Reviewer #2 (<https://doi.org/10.5194/egusphere-2024-1802-RC2>)

Review of "Benefits of a second tandem flight phase between two successive satellite altimetry missions for assessing the instrumental stability" by Ablain et al.

Fig. 26. GMSL differences between J3 and S6-MF LR NR over the side B tandem phase using the radiometer and CNES orbits (a), model and CNES orbits (b), model and JPL orbits (c)

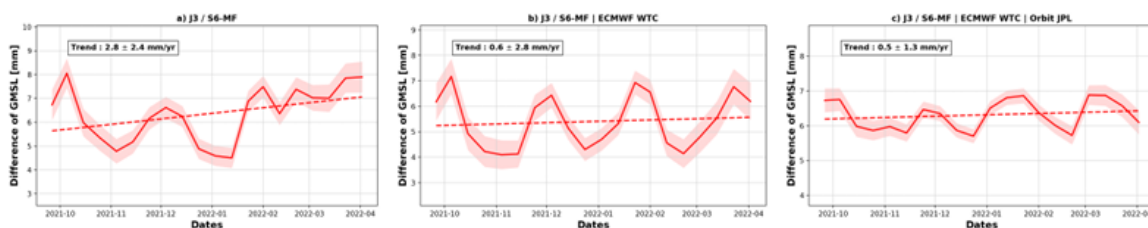
Line 154 (and figure 2). A 2-month periodic signal is mentioned in panel f. The attribution to POD is given without reasoning, and in fact POD uncertainties are part of the uncertainty budget you are trying to assess, so why removing it?

During the tandem phase, we observed a periodic signal in the GMSL differences between J3 and S6-MF. This signal, occurring over a two-month period, is attributed to differences in the Precise Orbit Determination (POD) calculations used for each satellite.

Recent research by Cadier et al. (submitted) has identified the source of this periodic signal as β' (beta-prime) dependencies within the CNES POD solution employed for S6MF. Their work demonstrates that using the JPL POD solution significantly reduces this 60-day error signal (see figure below from Cadier et al.).

While systematic GMSL differences arising from POD variations can occur during tandem phases, these discrepancies are typically resolved a few years after the tandem phase ends. This correction is achieved through adjustments to the POD calculations by POD experts, as has been the case for all tandem phases involving Topex/Poseidon, Jason-1, Jason-2, and Jason-3. Therefore, we consider the uncertainty due to POD discrepancies to be negligible in this study.

The paper offers now a more comprehensive justification for the aforementioned observation regarding the POD differences and the contribution of POD uncertainty.
